Best Wool Sweaters Ltd

Jarun, Konabari, Gazipur, Dhaka, Bangladesh
(+24.000421N, 90.323217E)

15th June 2014

Observations

Ground Floor Plan

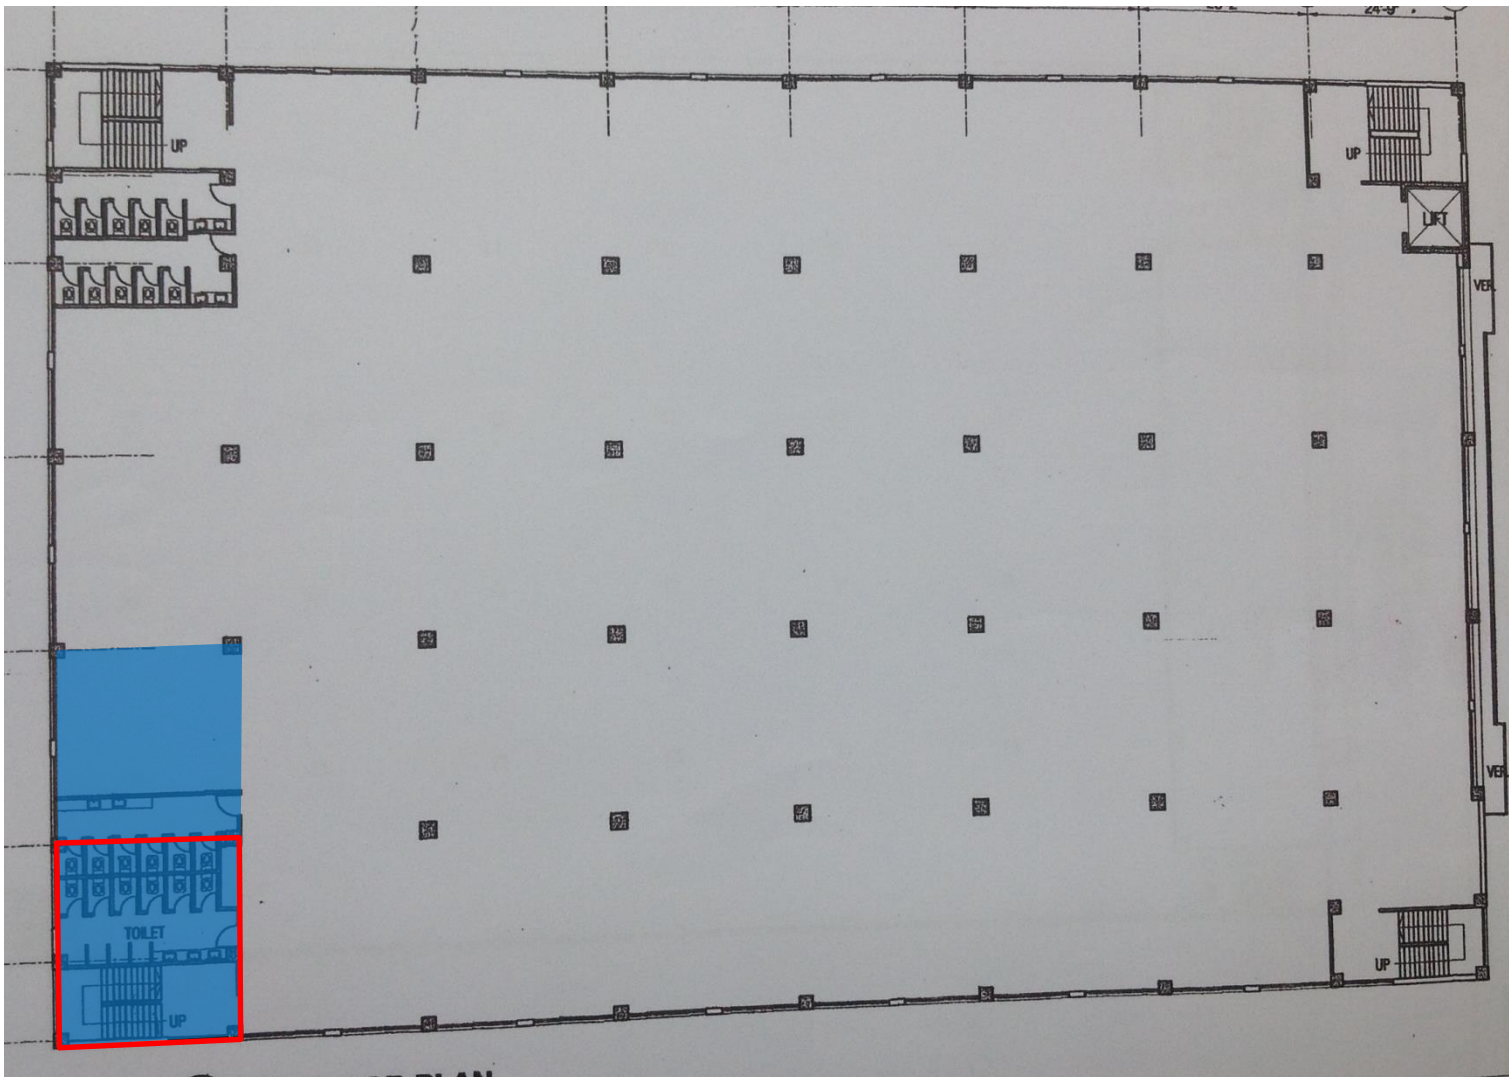
Column stresses in the North-East corner of the main building appear to be in excess of normal design limits

Cursory calculations indicate that column stresses in the N-E corner at Ground Floor level are in excess of normal design limits, due to significant water tank and toilet floor build-up loads.

Tested Columns

Stone aggregate was observed in the Ground Floor columns. High yield steel reinforcement is called up on the drawings and was observed in the columns at Roof level. Reinforcement quantities observed at Roof level and determined at Ground Floor level appear to be consistent with the drawings.

Item No.	Observation	Recommended Action Plan	Recommended Timeline
1	Column stresses in the North-East corner of the main building appear to be in excess of normal design limits - due to loading from the elevated Water Tank and significant Toilet floor build-up	Factory Engineer to review design, loads and column stresses in area of the building highlighted above.	6-weeks
2	Column stresses in the North-East corner of the main building appear to be in excess of normal design limits - due to loading from the elevated Water Tank and significant Toilet floor build-up	Verify insitu concrete stresses either by 100mm diameter cores or existing cylinder strength data for cores from 4 columns.	6-weeks
3	Column stresses in the North-East corner of the main building appear to be in excess of normal design limits - due to loading from the elevated Water Tank and significant Toilet floor build-up	Produce and actively manage a loading plan for all floor plates within the factory giving consideration to floor capacity and column capacity.	6-months

Typical Floor Plan

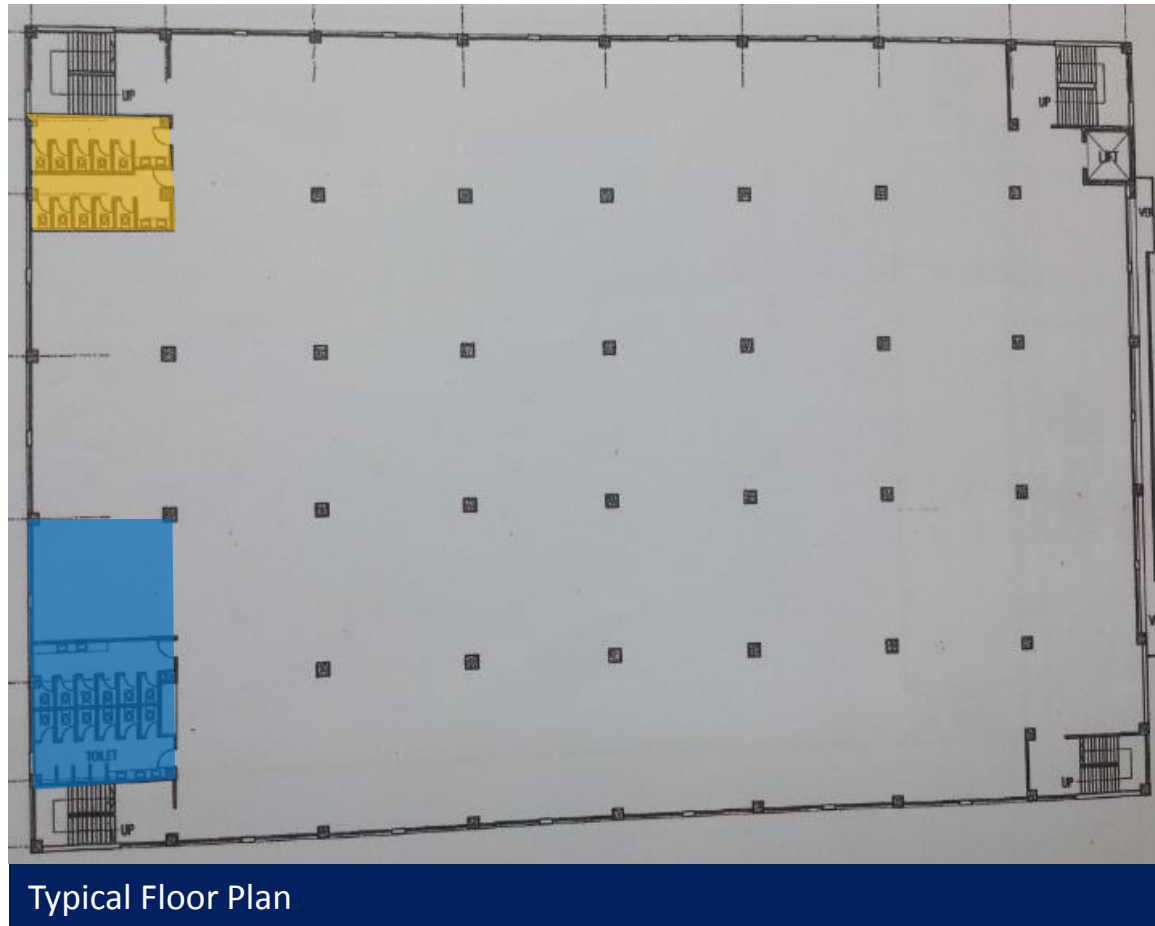
Extent of Toilets at all floor levels

Extent of Water Tank at Roof level

430mm average toilet floor build-up at all floor levels

Water Tank at Roof level

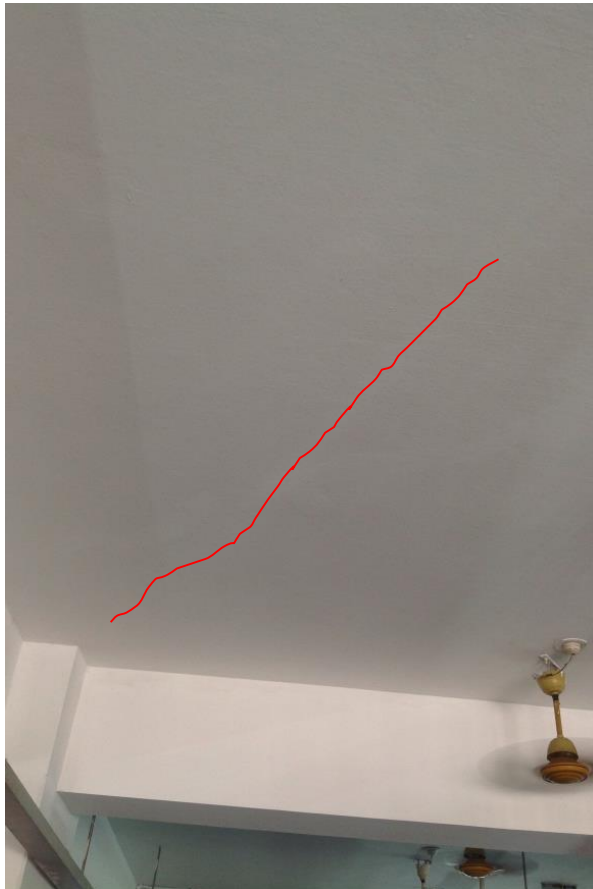
The Toilet block to the South-East corner, adjacent to Stair 3, is not in the location shown on the drawings other than at 1st Floor level. At all other floors, the majority of the Toilets are located to the North-East corner, adjacent to Stair 4, and, while these vary in size, occupy a larger area than is shown on the drawings.

Toilets typically not located in this area, other than at 1st Floor level

Toilet block in this area is typically larger than shown

Cracking to slab soffit

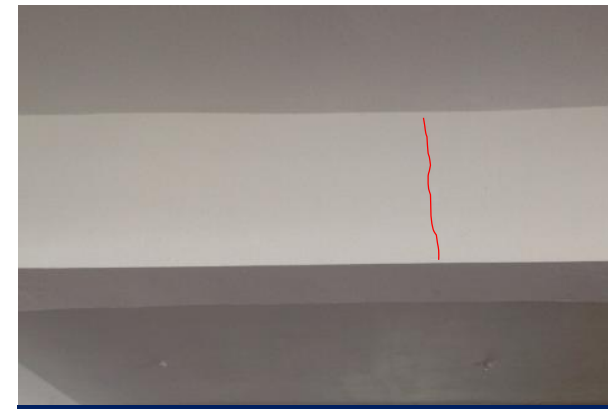
Hairline cracking to soffit of beams and slabs in main building

Hairline cracking was observed in the render to a number of beam and slab soffits at most floor levels. Cracking was also observed to the top of the slab. Note that a large number of cracks appear to have been filled and / or painted over. It is not clear whether the cracking extends into the concrete.

Item No.	Observation	Recommended Action Plan	Recommended Timeline
4	Hairline cracking to soffit of beams and slabs in main building	Monitor cracks to beams and slab soffit. Engage an engineer to investigate if cracks are only in the plastering.	6-months
5	Hairline cracking to soffit of beams and slabs in main building	Engage a Building Engineer to advise on load reduction and repair and strengthening of the slab if required.	6-months
6	Lightweight, apparently non-engineered roof structures to utility buildings	Engage a Building Engineer to review the design of all lightweight roof structures within the compound, and confirm their ability to withstand wind loading pressure, suctions and uplift forces, with special emphasis on connections and bracing.	6-months
7	Lightweight, apparently non-engineered roof structures to utility buildings	Building Engineer to implement any actions / supervise any remedial works as identified following the review.	6-months

Cracking to Beam Soffit

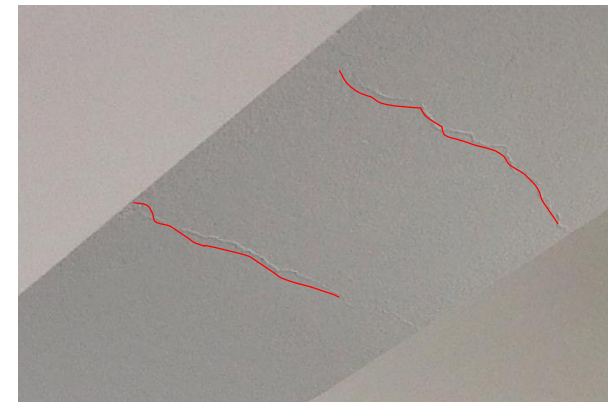
Filled Cracks to Beam Soffit
